SECTION 00 91 10

ADDENDUM NUMBER 1

- 1.01 DATE: MAY 14, 2018**
- 1.02 PROJECT: AUSTIN HIGH SCHOOL CAREER TECH CENTER**
- 1.03 PROJECT NUMBER: B. C. NO. 2018112**
- 1.04 OWNER: DECATUR CITY SCHOOLS**
- 1.05 ARCHITECT: NOLA | VAN PEURSEM ARCHITECTS, PC**

DETAIL: FAS PULL STATION

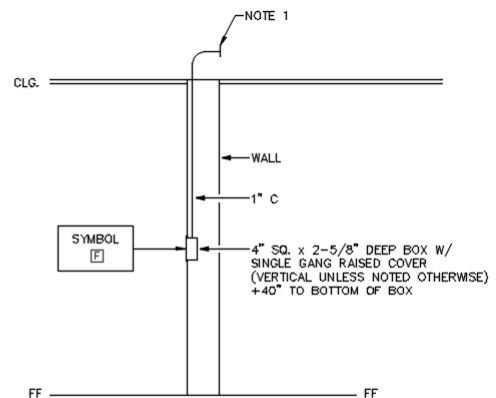
- (A) Add the following Details to the Contract documents:

DETAIL: HOOD AND EXHAUSTER

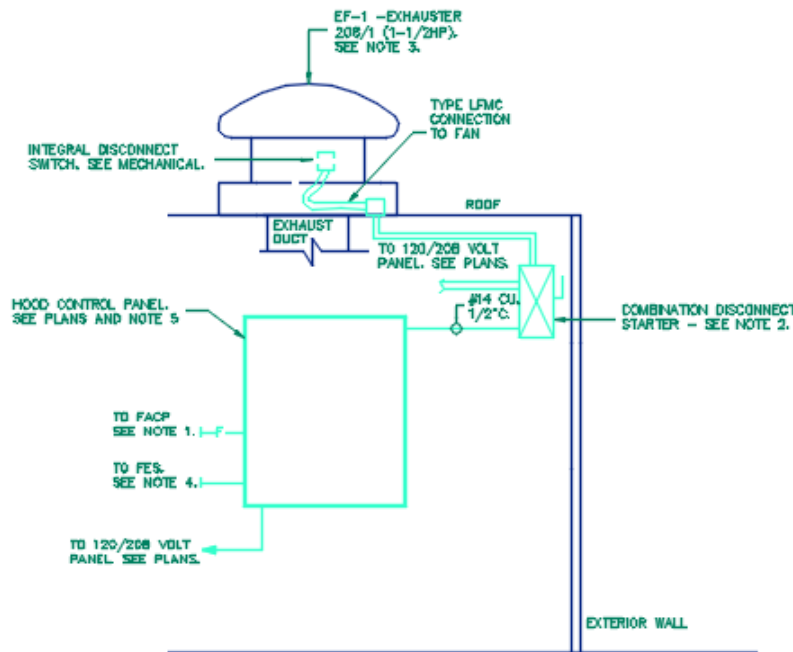
- (A) See below revised Hood and Exhauster detail:

1. PROVIDE CONNECTION TO FACP. UPON ACTIVATION OF HOOD EXTINGUISHING FACP WILL ACTIVATE.
2. COMBINATION NON-FUSED SAFETY SWITCH/NEMA SIZE 1 FVNR STARTER W/120VAC COILS IN NEMA 4XSS ENCLOSURE COMPLETE WITH THERMAL OVERLOAD UNITS. COORDINATE WITH HOOD SUPPLIER/INSTALLER FOR MOUNTING STARTERS TO HOOD STRUCTURE. VERIFY COIL VOLTAGE REQUIRED PRIOR TO ORDERING SWITCH.
3. COORDINATE ALL ASPECTS OF EXHAUST FAN ROUGHING W/ APPROVED SHOP DRAWINGS PRIOR TO ANY ROUGHING. FURNISH AND INSTALL ANY/ALL MATERIALS AND CONNECTIONS REQUIRED FOR A FULL FUNCTIONING HOOD AS SPECIFIED.
4. COORDINATE EXACT LOCATIONS, ELECTRICAL REQUIREMENTS, ROUGHING AND TERMINATIONS FOR NEW HOOD EXTINGUISHING SYSTEM WITH APPROVED EQUIPMENT SUBMITTALS AND INSTALLING CONTRACTOR PRIOR TO ANY ROUGHING AND/OR ORDERING MATERIALS.

11
A-2.1

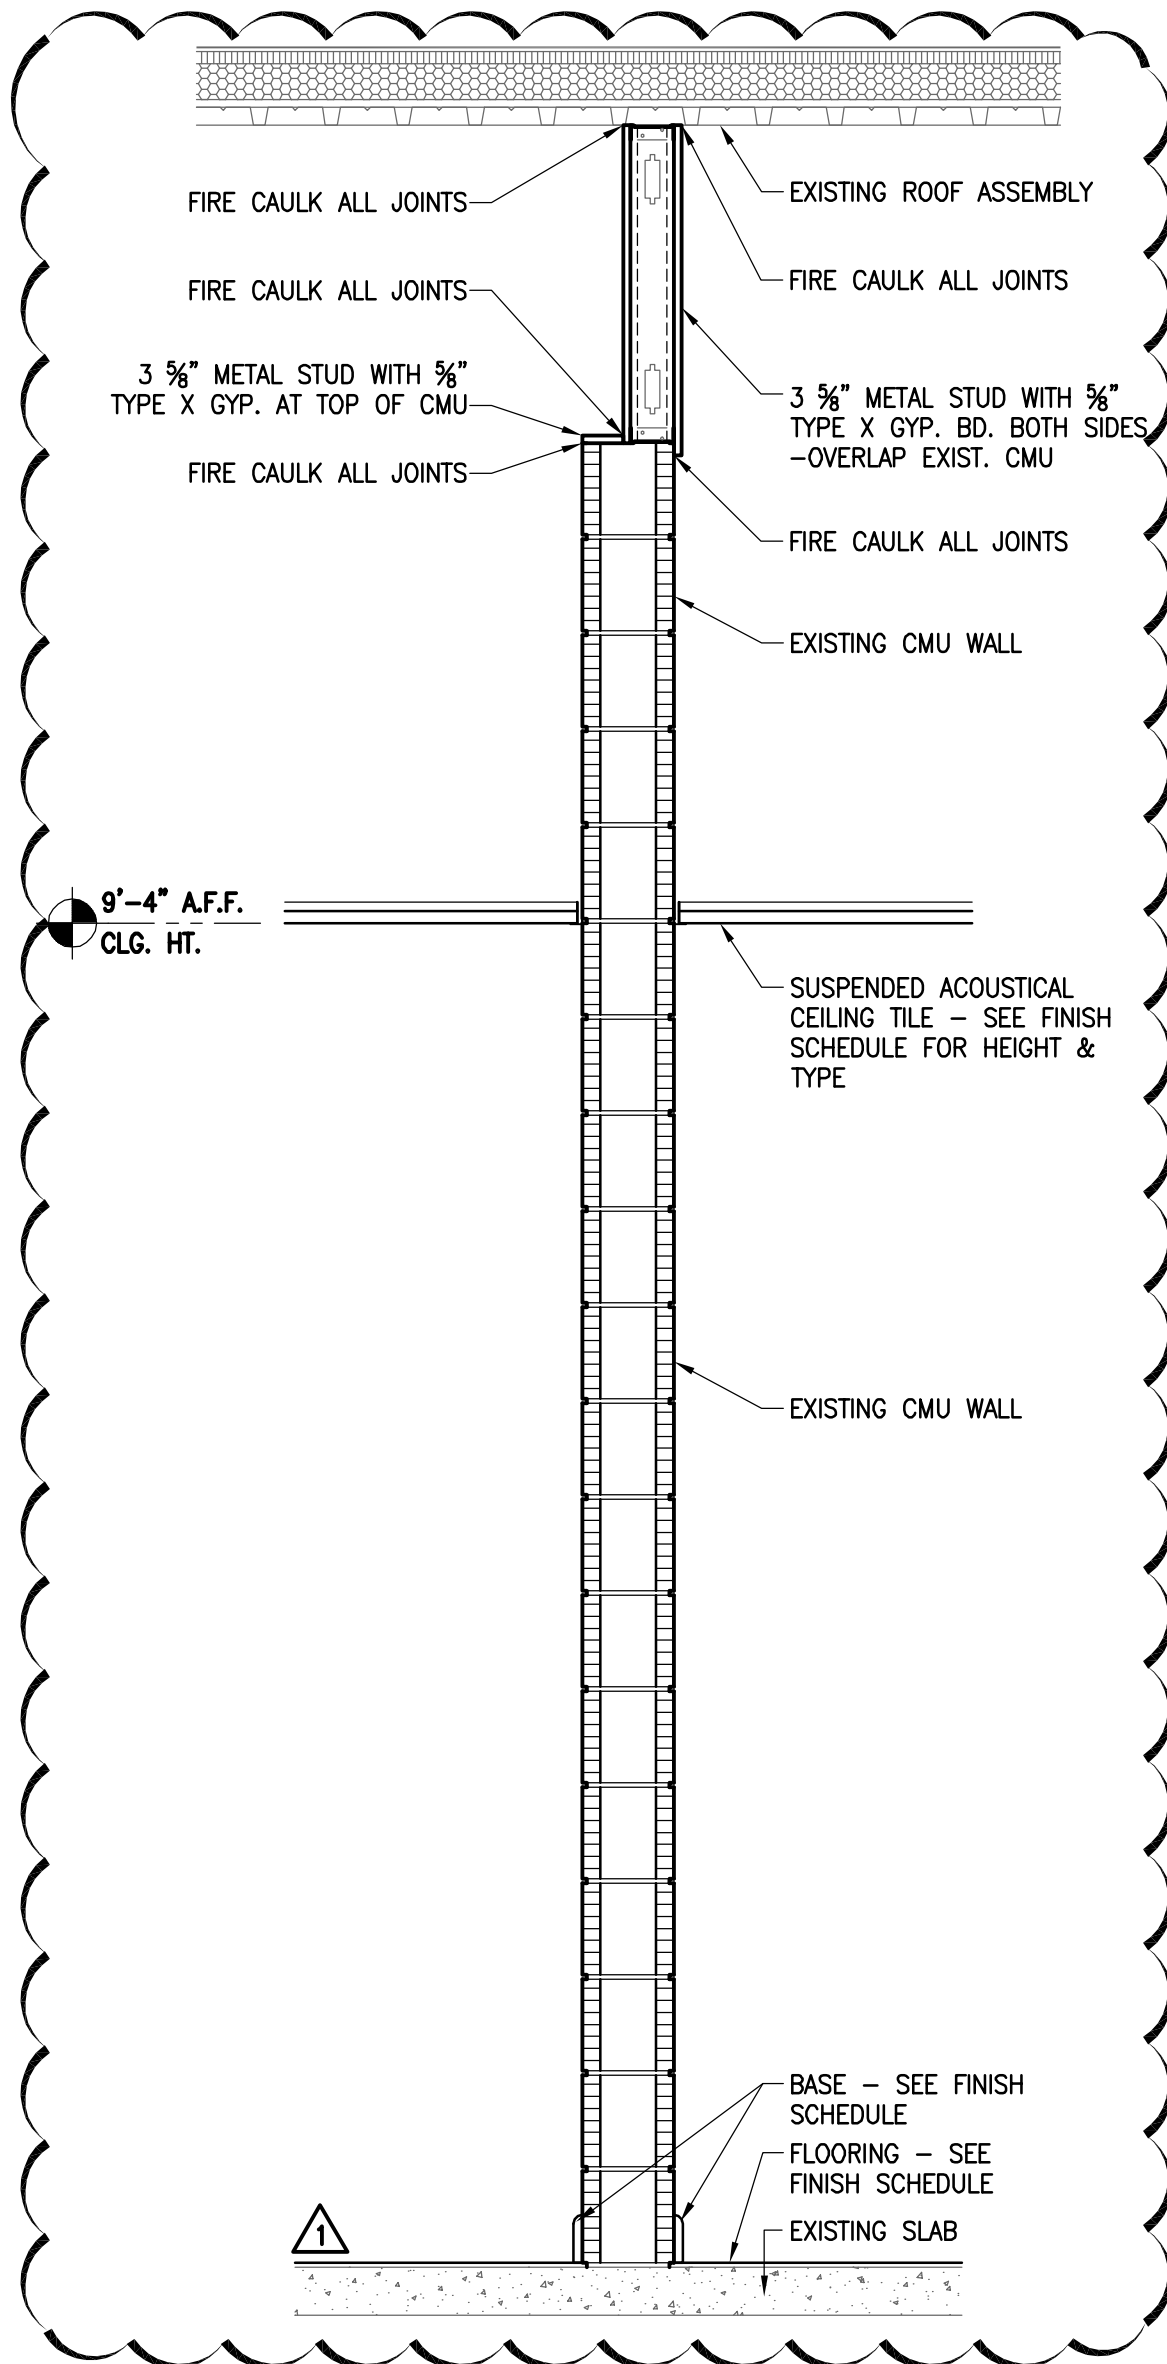
- A. Detail 7: Revise note reading "New Concrete Walkway" to read "New Concrete Walkway, 4 inch thick, 3000 PSI Concrete."
- B. Add Detail 11, per Attachment AD1-A2.1-01, for use at all existing walls shown to be 1 HR rated fire walls.

P-1.1
OF
8

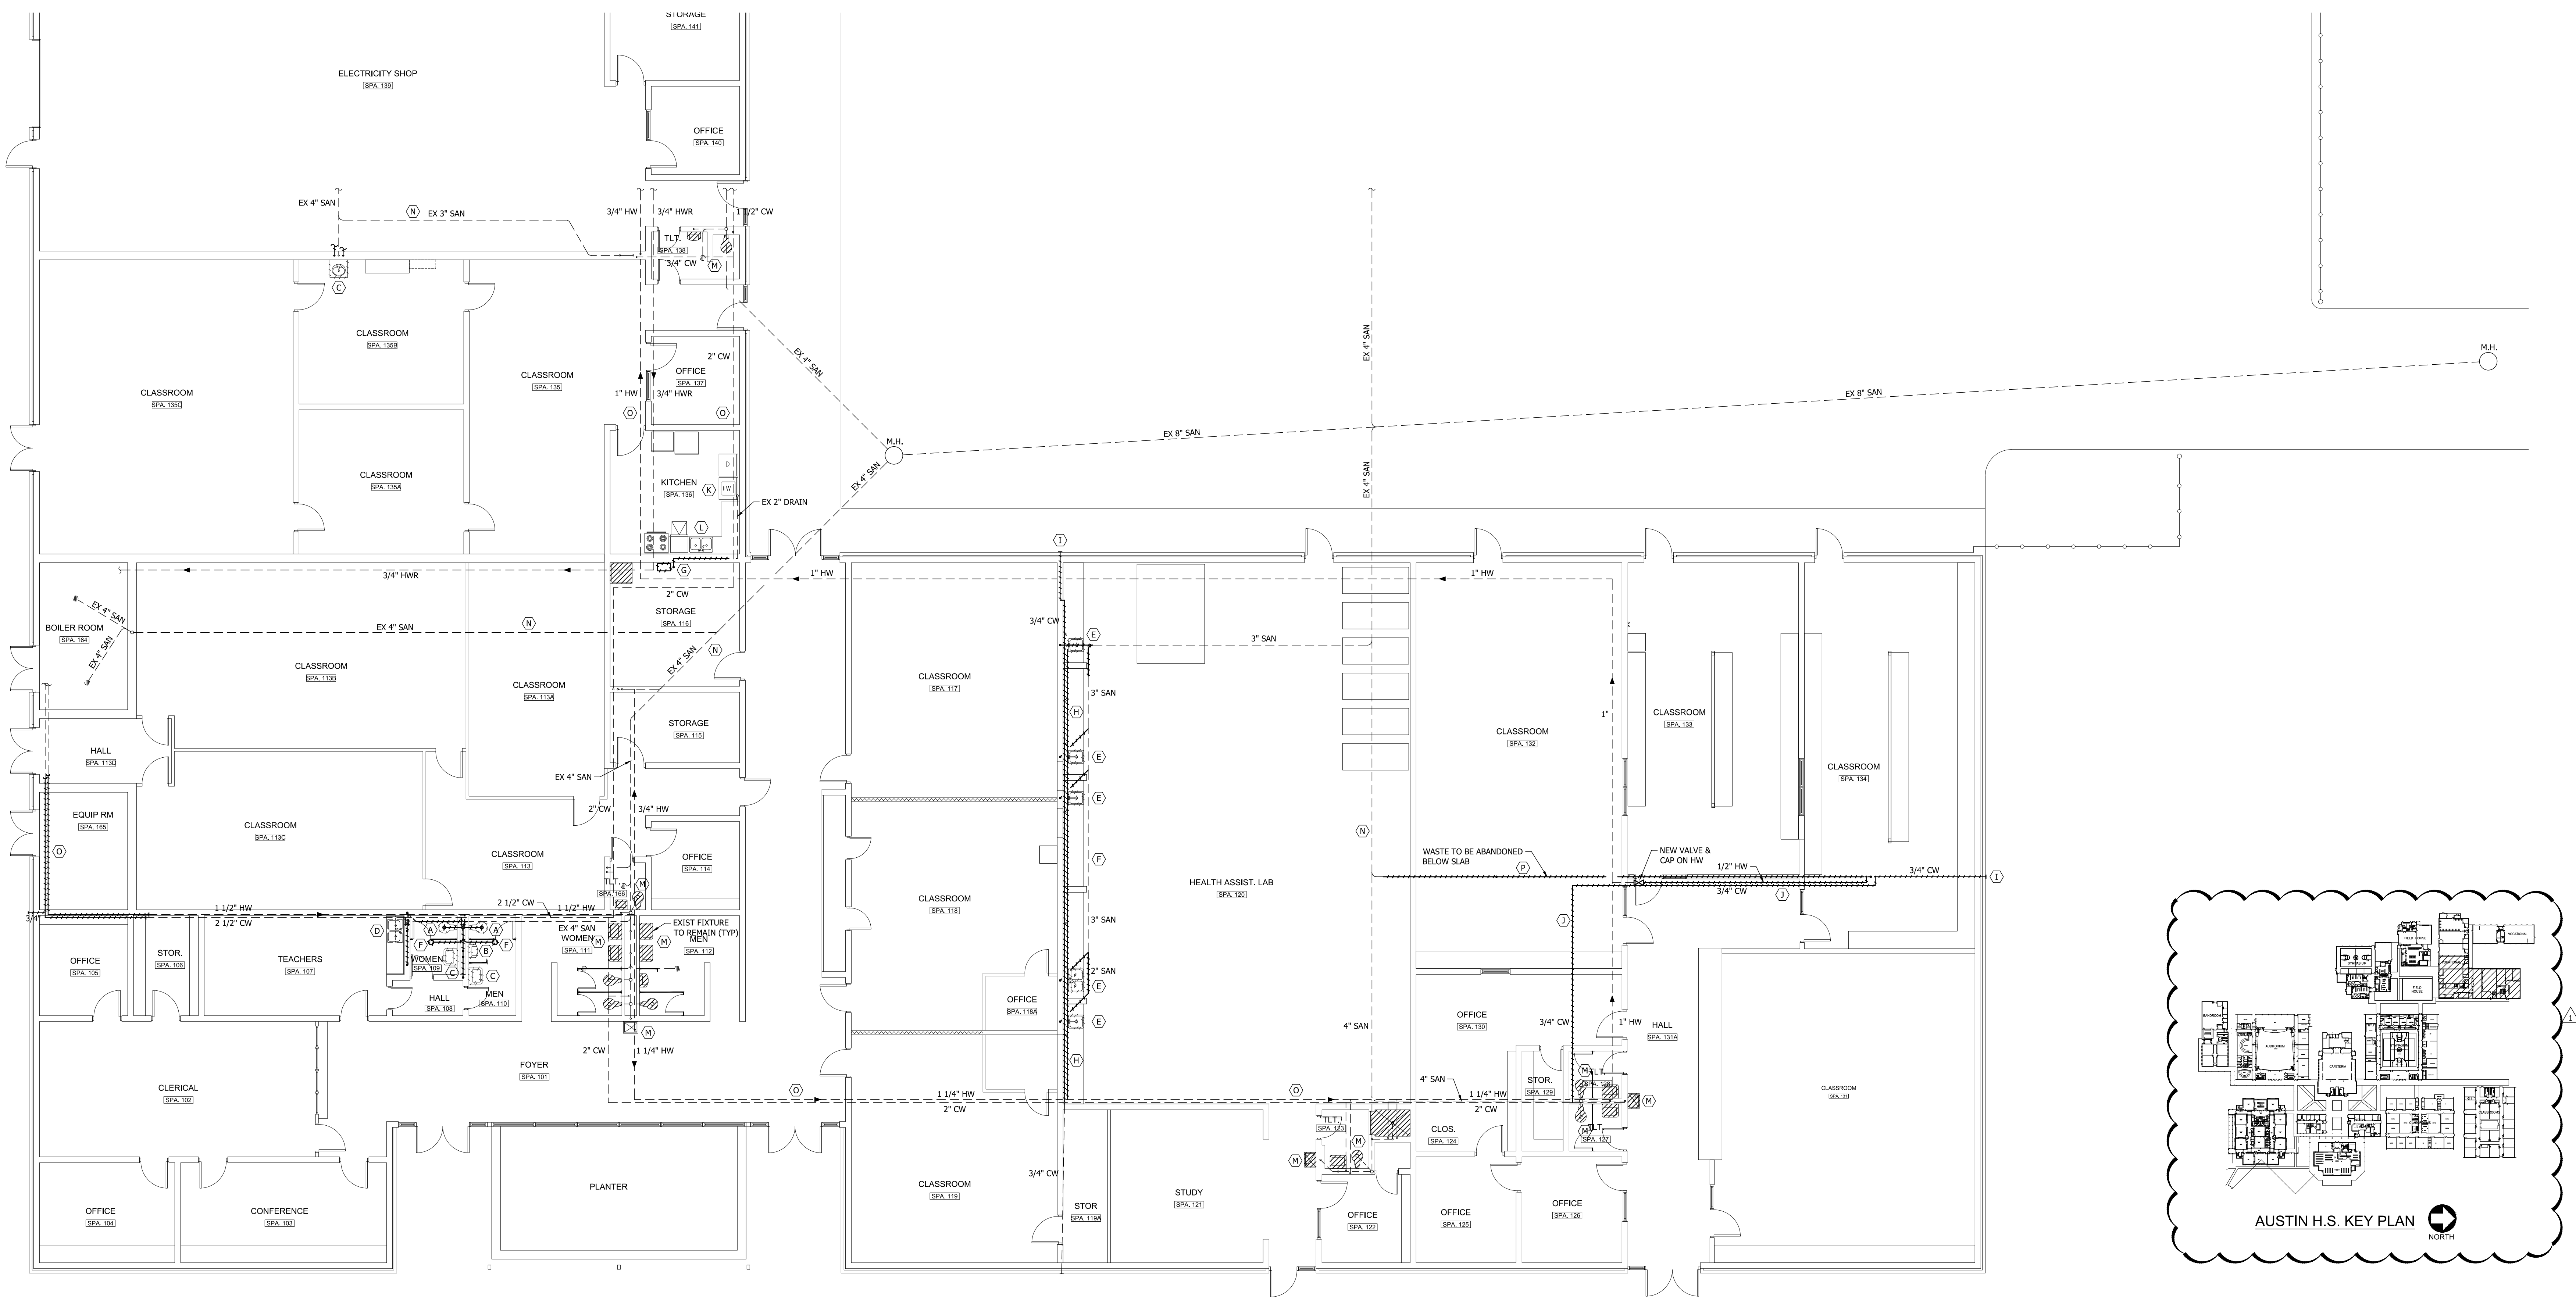
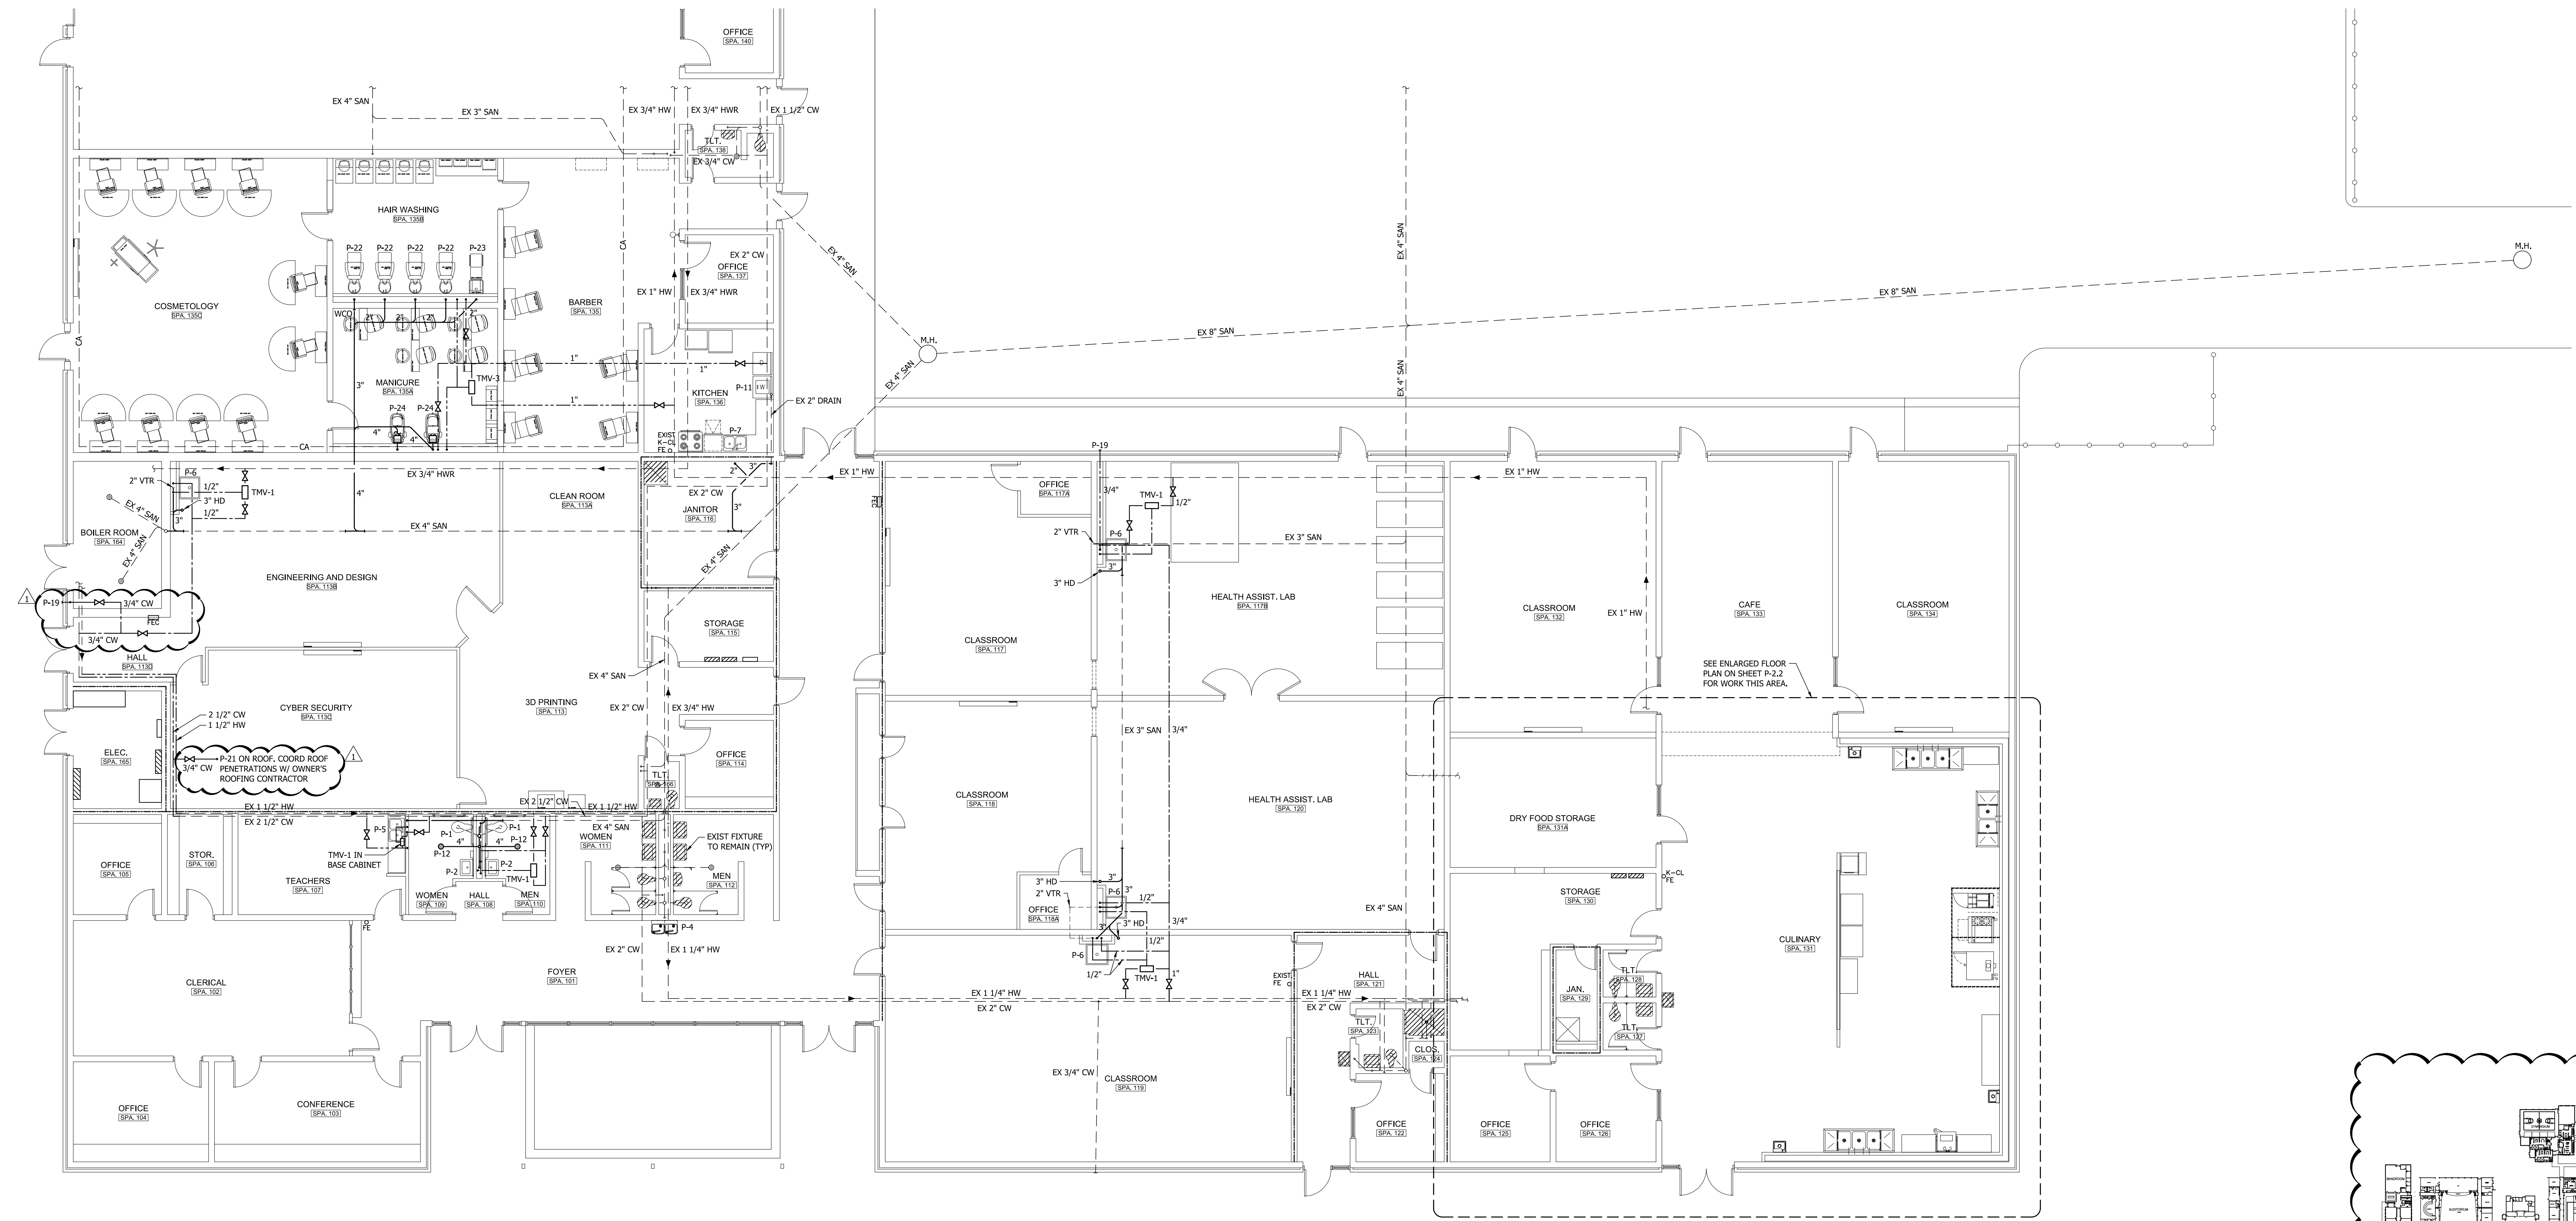
4.06 SHEET P-1.1 - PLUMBING DEMOLITION FLOOR PLAN:

- A. Replace this sheet in its entirety, the list of changes are as follows:
 - 1. Key plans have been re-labeled, re-positioned and the area of the work highlighted.
 - 2. Decatur HS plan scale has been increased to represent the actual listed scale.
 - 3. Two compartment sink with Key Note D is to be changed from to be demolished to be relocated.
